## Switching noise from climate relay

Topic number	LI83.30-P-066810
Version	2
Function group	83.30 Air conditioning
Date	08-21-2017
Validity	Model 453
Reason for change	Damage code updated
Reason for block

Anordnung Klimarelais SerieAlt.JPG:

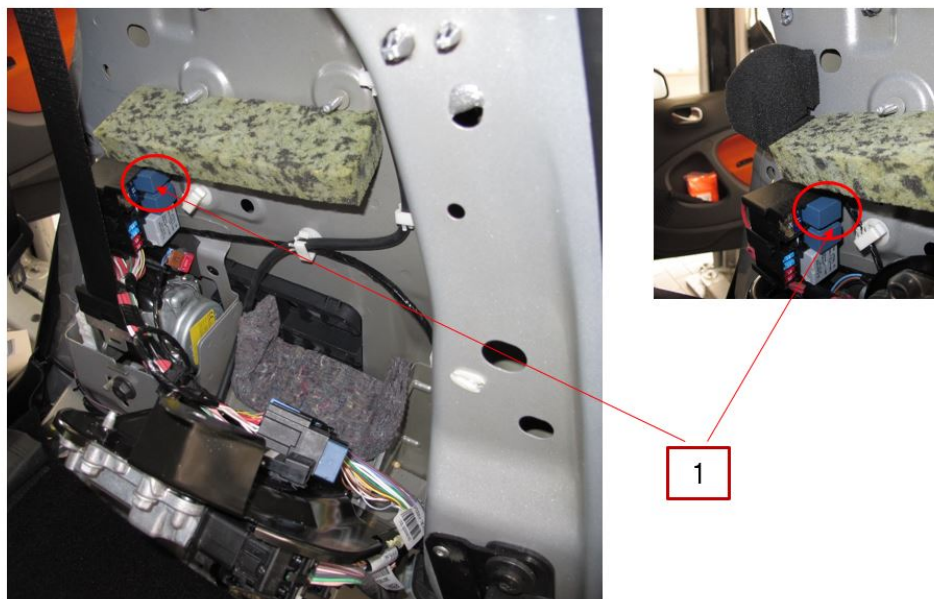
Switching noise from the climate relay (right B-pillar)

The previous attachment point on the B-pillar (photo 1) moves to the rear of the engine control unit bracket (photos 2 and 3).

Massnahme Klimarelais-Versetzen.JPG:

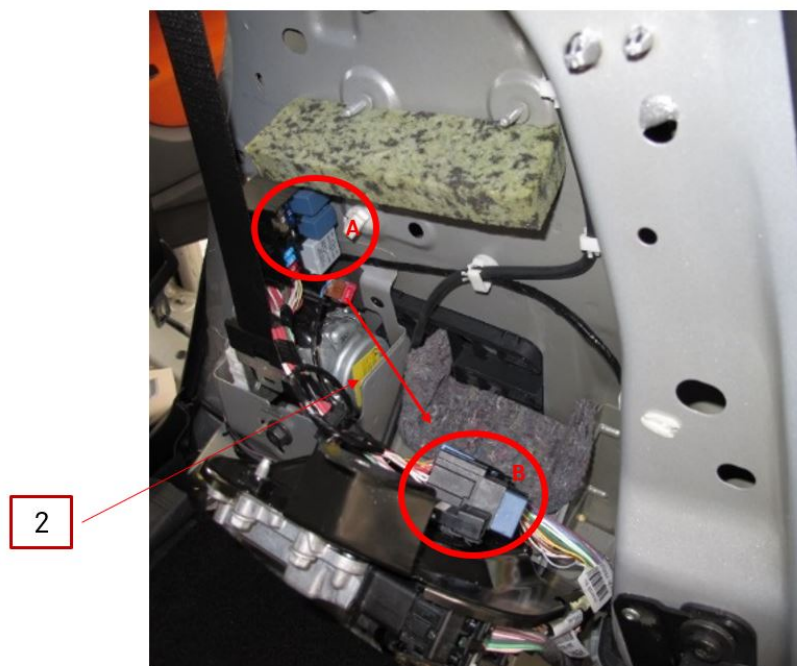
To relocate or reposition, remove the engine control unit bracket and detach the interior wiring harness in the routing area.

The climate relay can be relocated from the right B-pillar to the rear side of the engine control unit.
